MA121 2627b) Hopkins Land Review – snagging summary

Hopkins – Land Review

Update September 2026

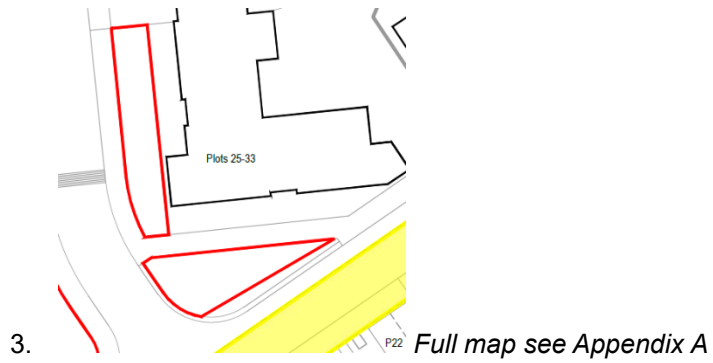
1. Grass quality low – suggest reseeding, weeding as required.
2. Hedge – assume hedging is not part of transfer – confirmation required.
3. Tree x 4 – to be reviewed when in leaf.

1. EH1 grass seed confirmed – cut as required (leave end June to end July for flowering).
2. Hedge – confirmation of transfer from plans required.
3. Tree reviewed as acceptable.

- Confirmed tend to hedge line.

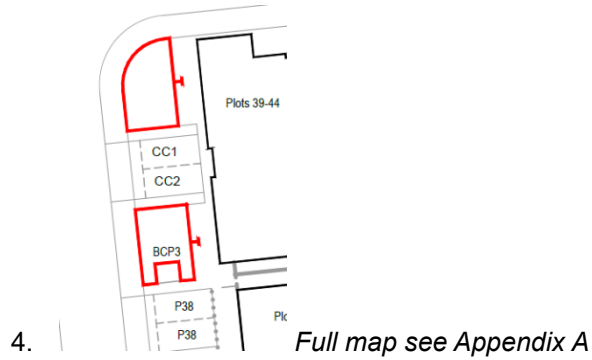
1. Grass quality low – suggest reseeding, weeding as required.
2. Hedge – assume hedging is not part of transfer.
3. Raised ironworks within hedge border.
4. Tree x 2 – to be reviewed when in leaf.

1. EH1 grass seed confirmed – cut as required (leave end June to end July for flowering).
2. Hedge – confirmation of transfer from plans required.
3. Raised ironworks not to be changed – not considered an issue.
4. Tree reviewed as acceptable.

- Confirmed tend to hedge line.

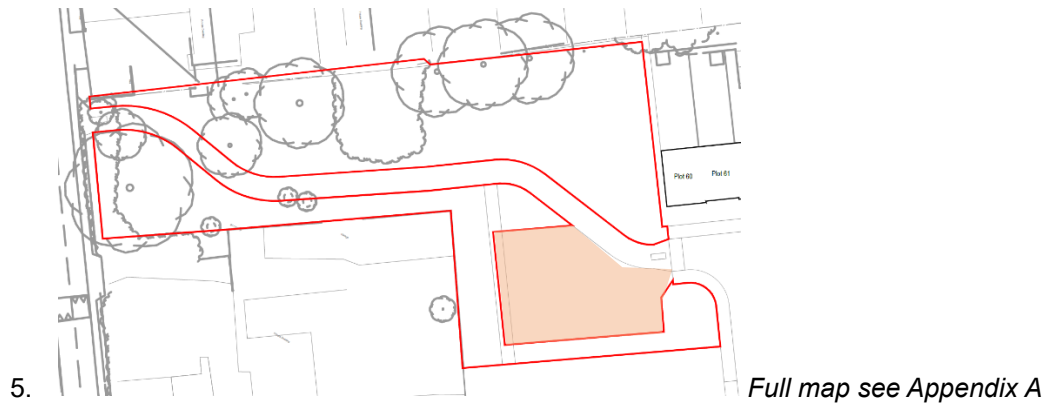
1. Grass quality low – suggest reseeding, weeding as required.
2. Hedge / shrubbery – to be reviewed when in leaf.
3. Trees – to be reviewed by arborist.
4. Raised ironwork within mowing area – to be lowered to allow for safe mowing.
5. Fenceline overgrown and weedy – to be tidied.

1. EH1 grass seed confirmed – cut as required (leave end June to end July for flowering).
2. Hedge reviewed as suitable.
3. Tree report received – concern over ivy cutting at base. To be confirmed. 2 trees to be replaced (dead).
4. Raised ironwork not considered an issue.
5. Fenceline to be tidied as agreed.

Note: contains area under highways control – shown above in orange. .

- Fenceline tidied.
- Base of tree to be cleared after Robin nesting season.
- Ivy on trees severed.

Note: contains substantial area to be assigned to Highways.

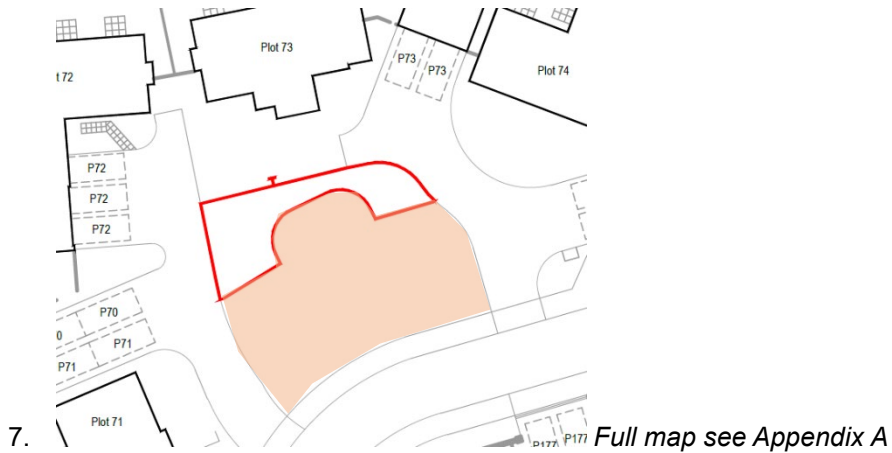
1. Grass quality low – suggest reseeding, weeding as required.
2. Restricted cuts during bulb flowering season.
3. Tree x 3 – to be reviewed when in leaf.
4. Shape of land highlighted on plan not reflective of area – confirmation required.

1. EH1 grass seed confirmed – cut as required (leave end June to end July for flowering).
2. Bulbs noted.
3. 2 trees in transfer – to be confirmed.
4. Area contains highways land.

Note: contains area under highways control – shown above in orange.

- Two trees to be replaced.

Note: contains substantial area to be assigned to Highways.

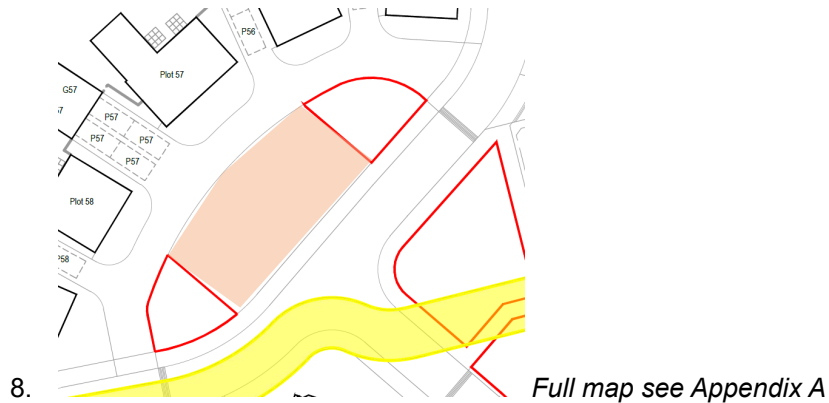
1. Grass quality low – suggest reseeding, weeding as required.
2. Shrubs – 2 areas of shrubs at either end of green area seem to be the only parts included in the transfer – confirmation of area needed.
3. Shape of land highlighted on plan not reflective of area – confirmation required.
4. Tree x 6 – to be reviewed when in leaf.

1. EH1 grass seed confirmed – cut as required (leave end June to end July for flowering).
2. Shrubs reviewed as acceptable.
3. 'Missing' area confirmed as highways.
4. Trees reviewed as acceptable.

Note: contains area under highways control – shown above in orange.

Note: contains substantial area to be assigned to Highways.

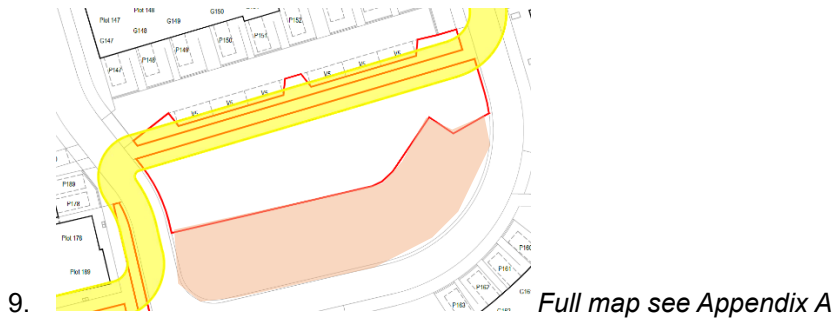
1. Grass quality low – suggest reseeding, weeding as required.
2. Raised iron works in mowing area.
3. LEAP - Confirmation of up-to-date RoSPA inspections required.
4. LEAP - Confirmation of warranty on play equipment required.
5. LEAP – fix swing (noted this has been booked by Hopkins).
6. LEAP - Fix to gate in play area required.
7. Hedge/shrubbery between path and parking area in need of attention.

1. EH1 grass seed confirmed – cut as required (leave end June to end July for flowering).
2. Raised ironworks considered acceptable.
3. ROSPA received – due April 2026
4. Warranty of play equipment required.
5. Swing fixed.
6. Gate fixed.
7. Shrubs reviewed as acceptable.

Note: contains area under highways control – shown above in orange.

- Copy of April 2026 RoSPA required.
- Confirm area to run from edge of shrub bed as shown on red line.
- Check gate suitability on RoSPA report.
- Note two bins on LEAP.

Note: contains substantial area to be assigned to Highways.

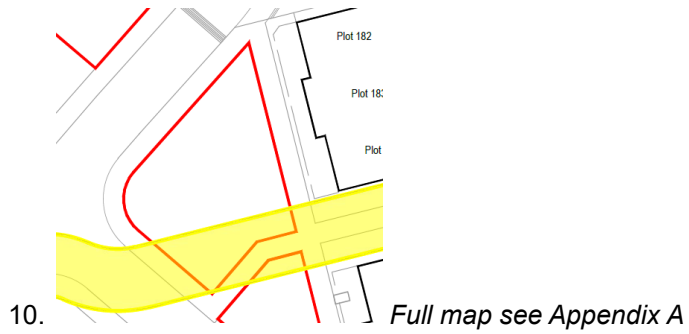
1. Grass quality low – suggest reseeding, weeding as required.
2. Shrubs – to be reviewed when in leaf.
3. Tree x 6? – to be reviewed when in leaf.

1. EH1 grass seed confirmed – cut as required (leave end June to end July for flowering).
2. Shrubs reviewed as acceptable.
3. Trees reviewed as acceptable.

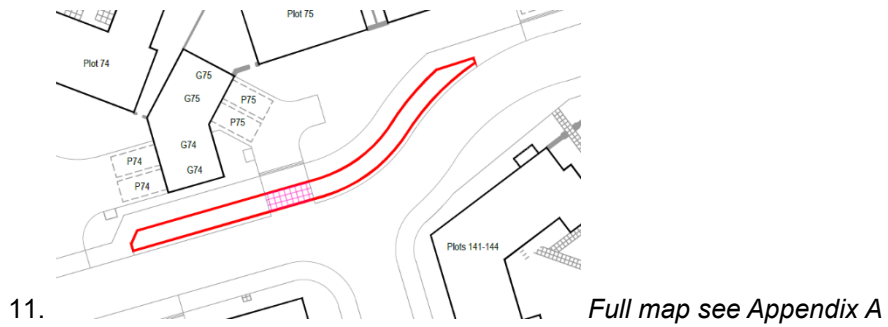
1. Grass quality low – suggest reseeding, weeding as required.

- Require confirmation of area – may not be as red line above. Sharon to confirm if additional area, shown in solid red below, is included.

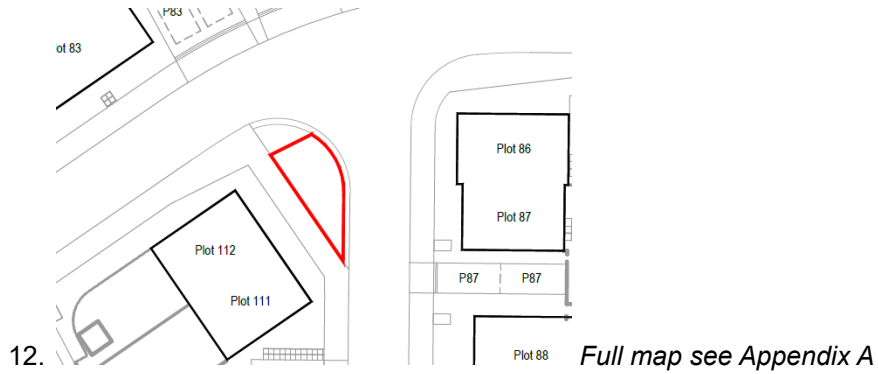
- Grass quality low – suggest reseeding, weeding as required.
- Tree x 1 – may need replacing as seems to be dead – to be reviewed when in leaf.

1. EH1 grass seed confirmed – cut as required (leave end June to end July for flowering).
2. Tree to be replaced (dead).

- Tree to be replaced.

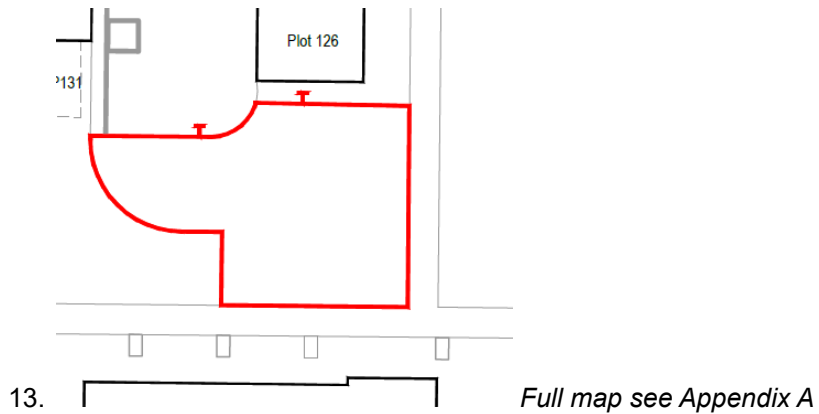
1. Grass quality low – suggest reseeding, weeding as required.
2. Tree x 3 – to be reviewed when in leaf.
3. Are shrubs planted along fence line of properties included – confirmation required.

1. EH1 grass seed confirmed – cut as required (leave end June to end July for flowering).
2. Trees reviewed as acceptable.
3. Confirmed shrubs along fence line as homeowners.

14.  Full map see Appendix A

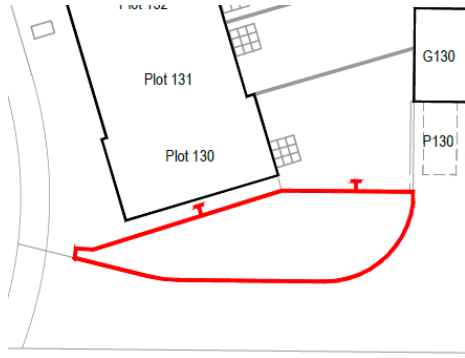
1. Grass quality low – suggest reseeding, weeding as required.
2. Tree x 1 – to be reviewed when in leaf.
3. Are shrubs planted along fence line of properties included – confirmation required.

1. EH1 grass seed confirmed – cut as required (leave end June to end July for flowering).
2. Tree reviewed as acceptable.
3. Confirmed shrubs along fence line as homeowners.

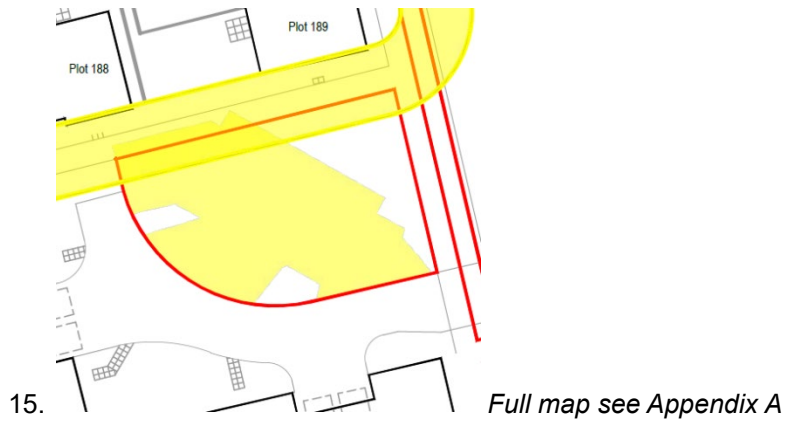
1. Grass quality low – suggest reseeding, weeding as required.
2. Shrubs – to be reviewed when in leaf.
3. Tree x 3 – to be reviewed when in leaf.

1. EH1 grass seed confirmed – cut as required (leave end June to end July for flowering).
2. Shrubs reviewed as acceptable.
3. 1 tree to be replaced (dead).

- One tree to be replaced.

16. *Full map see Appendix A*

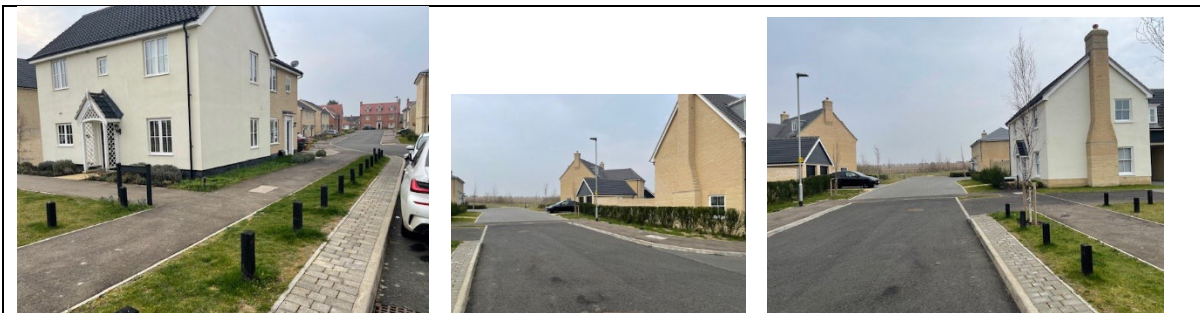
1. Grass quality low – suggest reseeding, weeding as required.
2. Hedge – assume hedging is not part of transfer – confirmation required.

1. EH1 grass seed confirmed – cut as required (leave end June to end July for flowering).
2. Confirmed hedge to belong to homeowners.

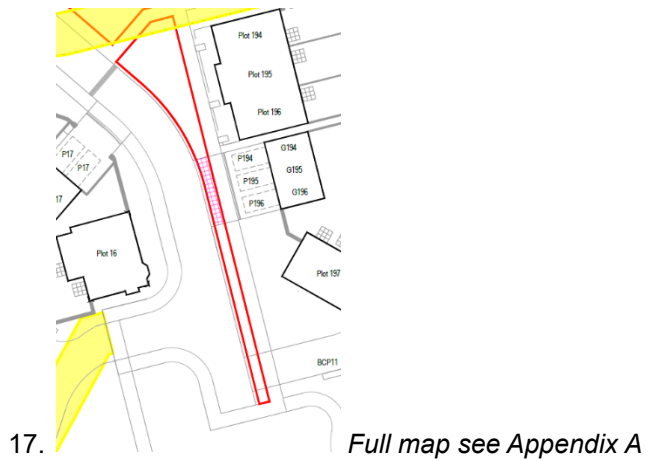
1. Grass quality low – suggest reseeding, weeding as required.
2. Damage to bollard – to be replaced.

1. EH1 grass seed confirmed – cut as required (leave end June to end July for flowering).
2. 2 bollards to be replaced due to damage.
3. 1 tree to be replaced (dead).

- Three trees to be replaced.
- Two bollards to be replaced.

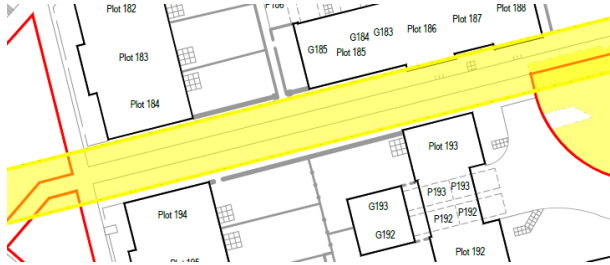
- Confirmation of walkway area between Poppy Crescent and Lavendar Lane – are these two strips of land maintained by homeowners as they do not appear on the plans for handover.
- June 25 – confirmed responsibility of highways / homeowner (street lights included).

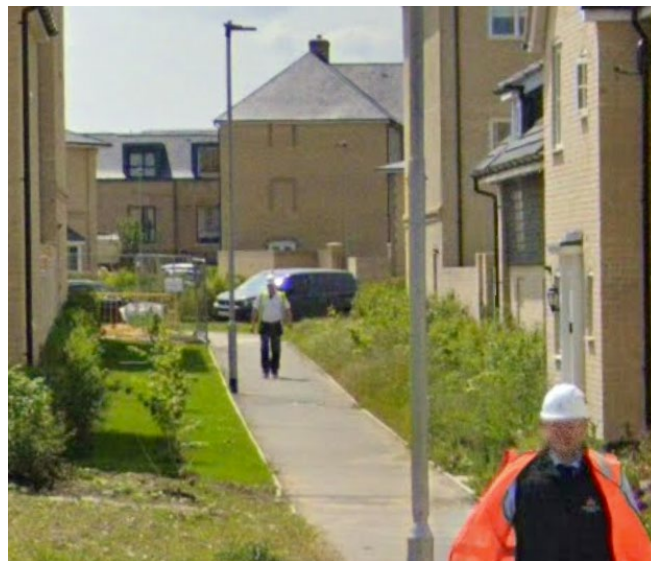
- Grass quality is poor throughout the estate – this would need addressing before handover.
 - June 25 - Addressed as EH1 grass seed throughout – cut as required (leave end June to end July for flowering).
 - Suggested care as above.
- Review of trees
 - June 25 – trees in need of replacement noted (to be completed in winter 25).
 - September 26 – trees in need of replacement noted as 9 (to be completed late 26).
- SGB (wildflower)
 - Suggested annual cut at Poppy Crescent end (tussock grass).
 - Cut and collect with mown paths for other areas.
